**ITB #2025-018906**

## **HOVLAND HALL WEST WING REMODEL CONSTRUCTION SERVICES**

### **ADDENDUM NO. 1**

OSU Hovland Dry Lab Remodel

A-111

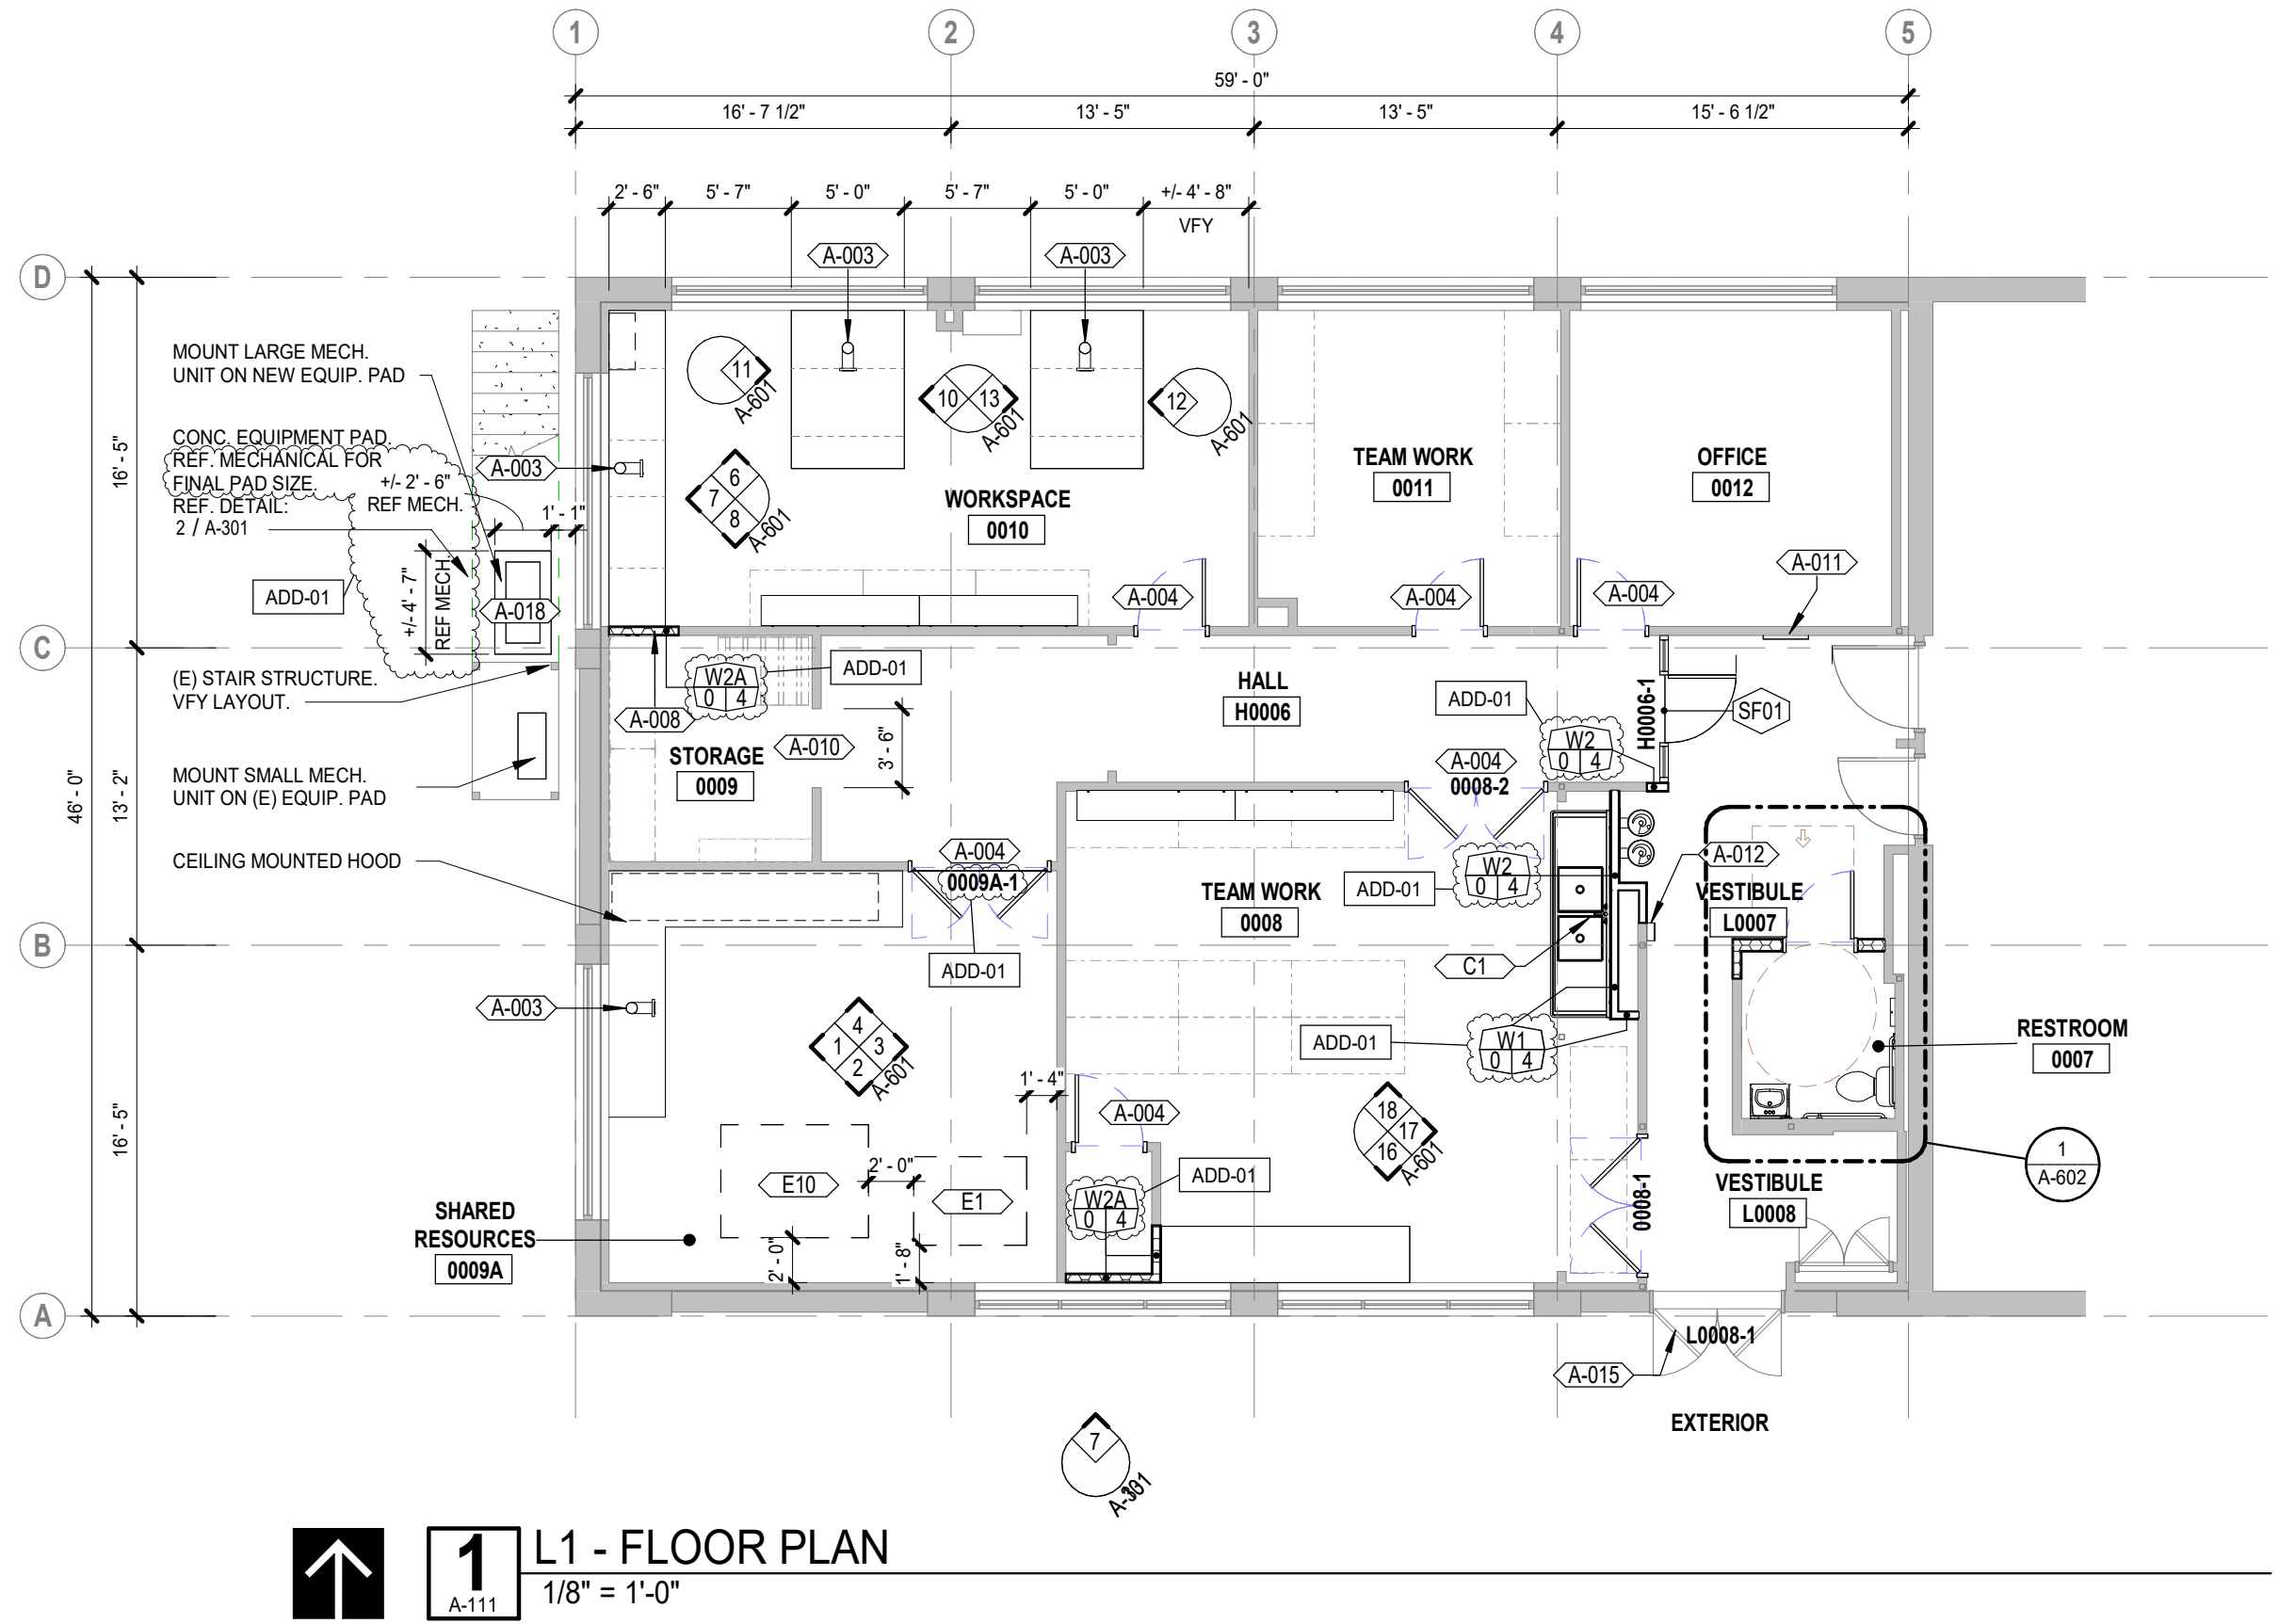
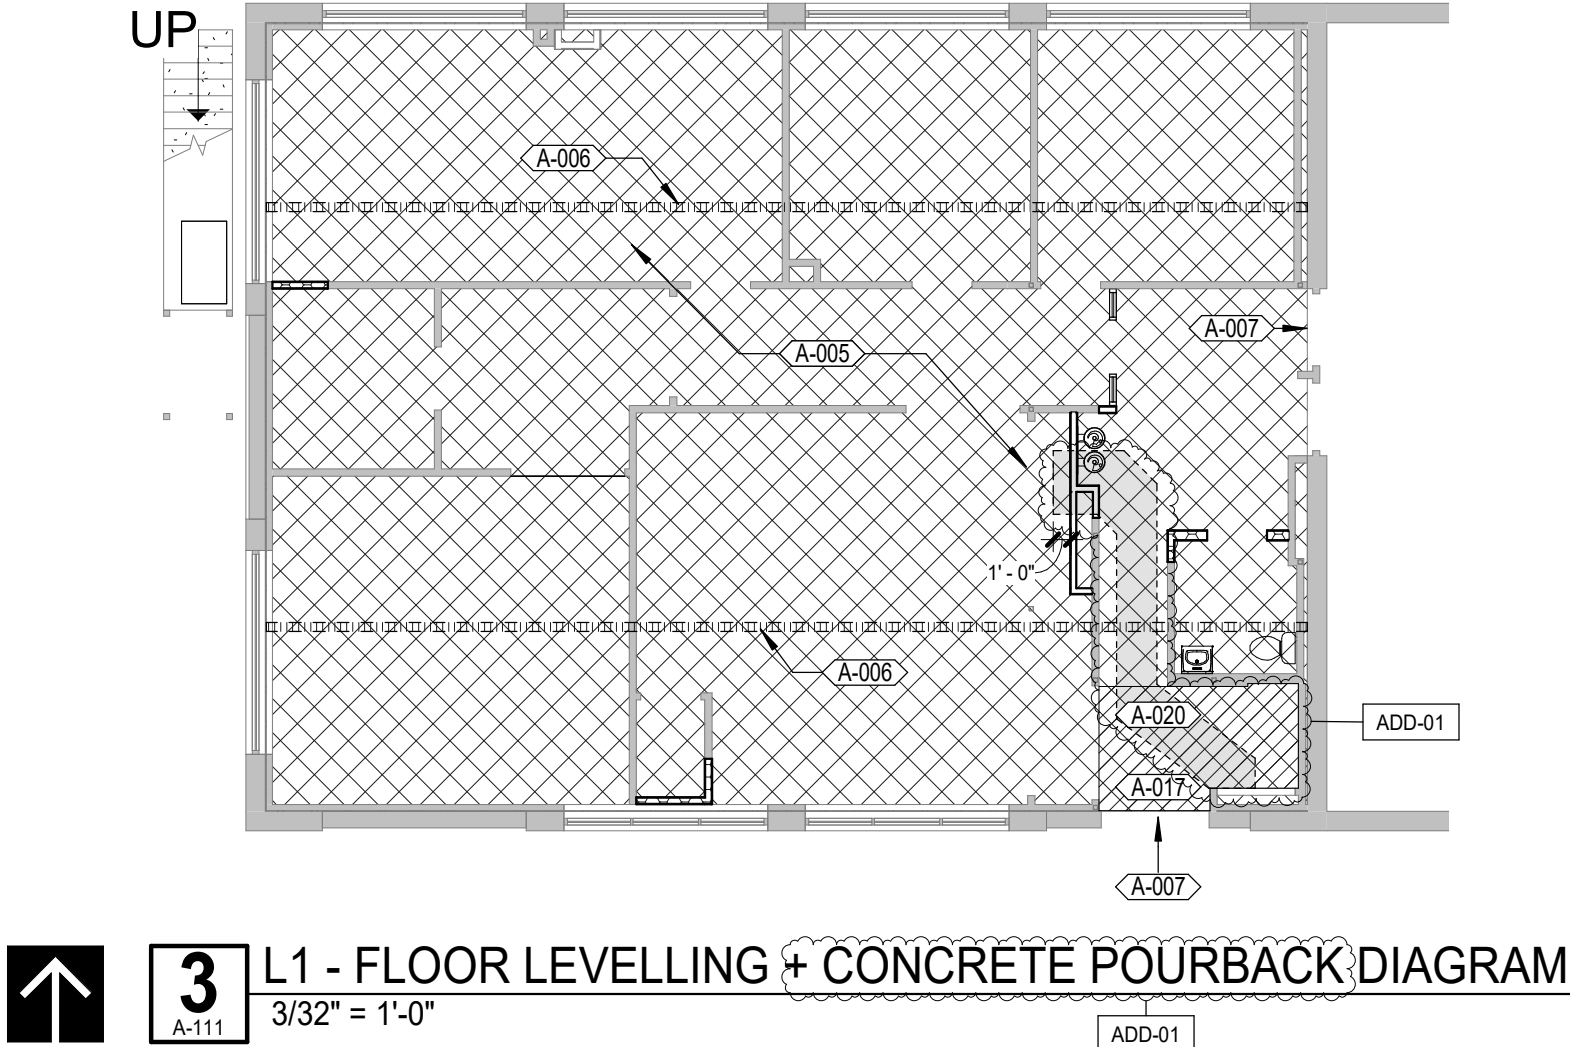
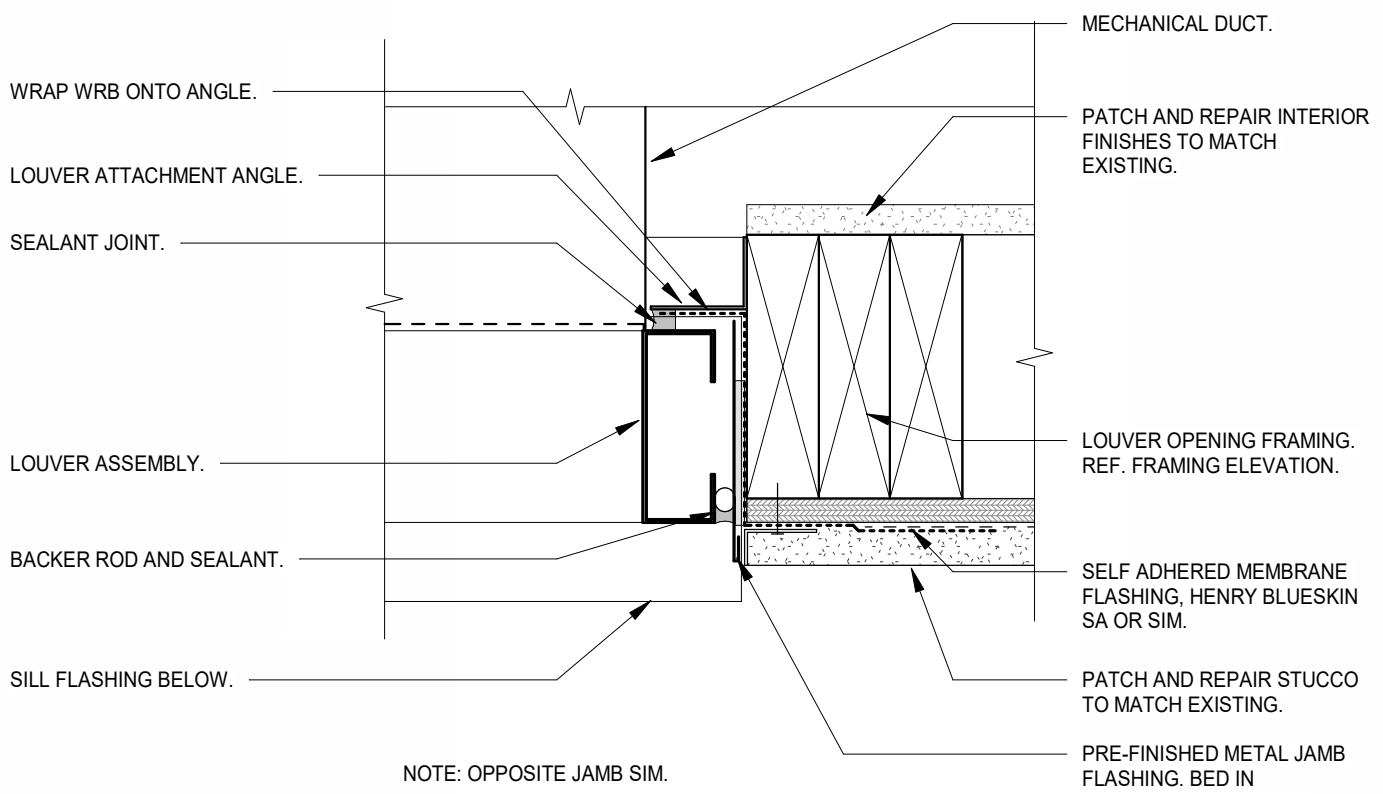
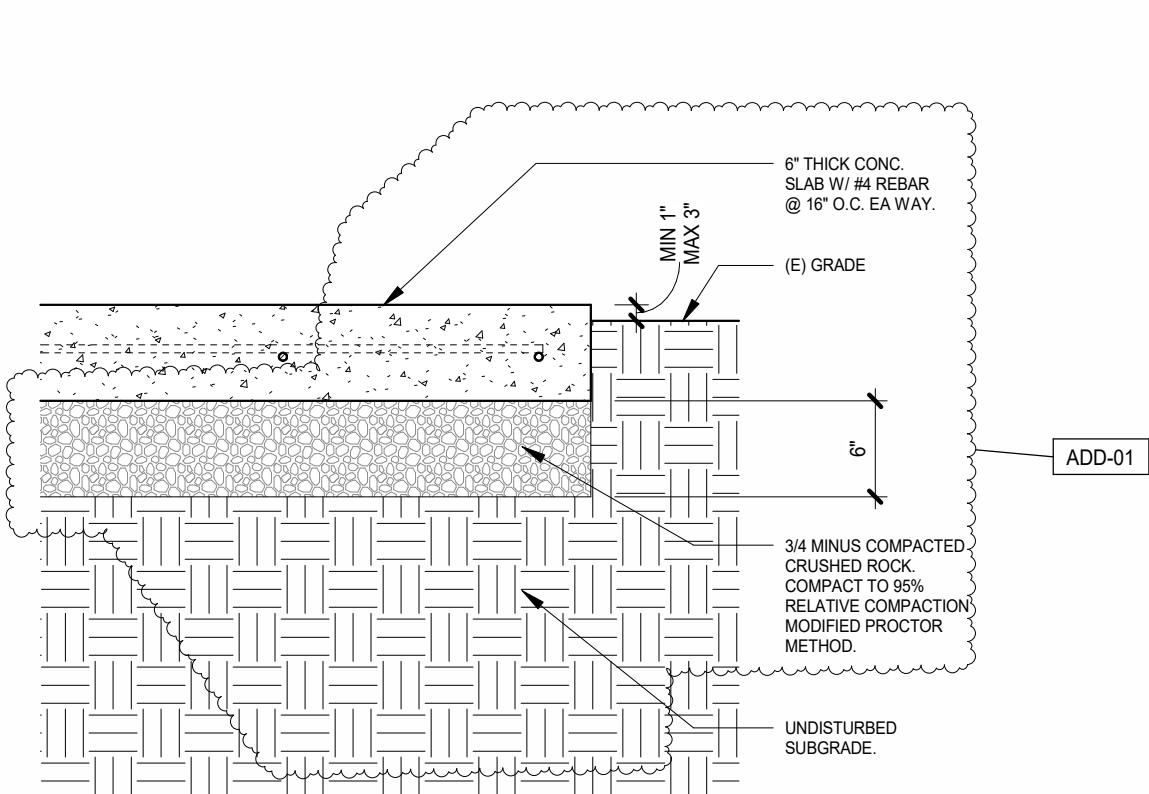
- 1) Sheet A-050 (re-issued, attached). Revisions include:
  - a) Demolition plan revised as shown.
  - b) Keynotes revised as shown.
- 2) Sheet A-111 (re-issued, attached). Revisions include:
  - a) Floor Plan revised as shown.
  - b) Reflected Ceiling Plan Revised as shown.
  - c) Floor Levelling + Concrete Pourback Plan revised as shown.
  - d) Keynotes revised as shown.
- 3) Sheet A-301 (re-issued, attached). Revisions include:
  - a) Detail # 2 revised as shown.
- 4) Sheet A-501 (re-issued, attached). Revisions include:
  - a) Door schedule and notes revised as shown.
- 5) Sheet A-601 (re-issued, attached). Revisions include:
  - a) Elevation 1 revised as shown.
  - b) Keynotes revised as shown.
- 6) Sheet A-602 (re-issued, attached). Revisions include:
  - a) Elevations 2-6 revised as shown.
  - b) Enlarged Plan revised as shown.

| LEGEND - KEYNOTES |  |
|-------------------|--|
| A-019             | REMOVE AND REPLACE ACT CEILING AT AREAS OF MECHANICAL WORK SHOWN HATCHED. MINIMUM AREA MATCH EXISTING CEILING. NEW LIGHT FIXTURES THROUGHOUT. REF ELECTRICAL. ADD-01 CONTRACTOR'S OPTION TO REMOVE AND REINSTALL EXISTING CEILING GRID.  |
